**Notice of Allowability**

10/519,322

CHEN ET AL.

### EXAMINER'S AMENDMENT

FIG. 4

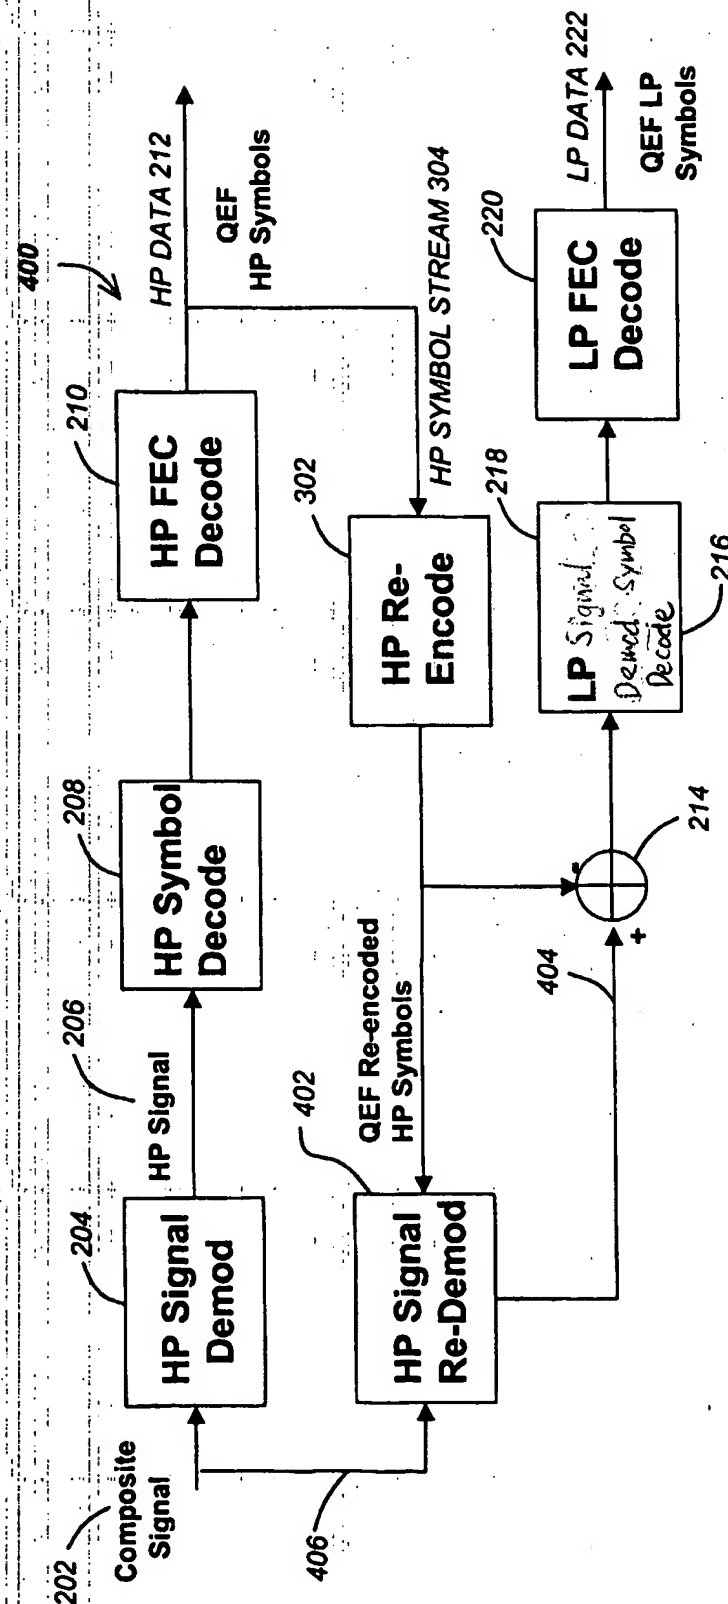
2. The following changes to the drawings have been approved by the examiner and agreed upon by applicant: element box 216 or 218 is changed to describe the element box as "LP Signal Demod / Symbol Decode". In order to avoid abandonment of the application, applicant must make these above agreed upon drawing changes.
